Access Compliance Report

Public Rights-of-Way

(Curb Ramps)

Intersection ID: 8931	Main Street: BANCROFT_ST	Cross Street: ENNIS_AV	Location: S
ADA ID: 66B62D5658D6	Ramp Type: BlendTrans1	Initial Pass/Fail: Fail	Overall Compliance: No
Severity Score: 12.5			
Codes/Mitigation Info/Possible Solution		Field Measurements/Component Compliance

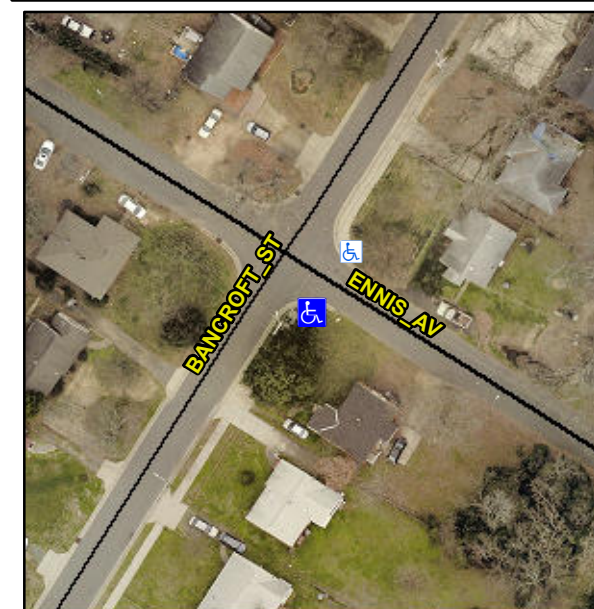
Compliance	Description	Data	Compliance	Description	Data
N/A	Ramp Length (in)	63.0	Yes	BlendTrans Slope (%)	4.5
Yes	Ramp Width (in)	58.0	No	BlendTrans XSlope (%)	5.4
N/A	Flare Type LT	N/A	N/A	Flare Type RT	N/A
N/A	Flare Slope LT (%)	N/A	N/A	Flare Slope RT (%)	N/A
N/A	Flare Traversable LT?	N/A	N/A	Flare Traversable RT?	N/A
N/A	Landing Length (in)	N/A	N/A	DWS Provided?	N/A
N/A	Landing Width (in)	N/A	N/A	DWS Contrast?	N/A
N/A	Landing Slope (%)	N/A	N/A	DWS Length (in)	N/A
N/A	Landing X Slope (%)	N/A	N/A	DWS Full Width?	N/A
N/A	Landing Curb? (Y/N)	N/A	N/A	DWS Offset (in)	N/A
N/A	Shared Landing?	N/A			
N/A	Gutter Ponding?	N/A	N/A	Gutter Slope (%)	N/A
N/A	Gutter Lip Ht (in)	N/A	N/A	Gutter X Slope (%)	N/A
N/A	Painted X Walk1?	No	N/A	Painted X Walk2?	N/A
	X Walk 1 Direction	To NE		X Walk 2 Direction	N/A
	X Walk 1 Width (in)	N/A		X Walk 2 Width (in)	N/A
	X Walk 1 Slope (%)	3.1		X Walk 2 Slope (%)	N/A
	X Walk 1 X Slope (%)	0.2		X Walk 2 X Slope (%)	N/A

N/A	Ramp inside XWalk1?	N/A	N/A	Ramp inside XWalk2?	N/A
	Road Slope (%)	0.2		Clear Space?	N/A
	Road X Slope (%)	3.1	N/A	Clear Space to XWalk (in)	N/A
N/A	Any Obstructions?	N/A	N/A	Storm Grate/Utility Hazard?	N/A
	Obstruction Type			Storm Grate/Utility Type	
		N/A			N/A
			Yes	Surface Condition? (G/P)	Good
			N/A	Curb Slope (%)	3.2

Remove & Replace Curb Ramp With Two New Directional Ramps or Equivalent.

R304.5.3
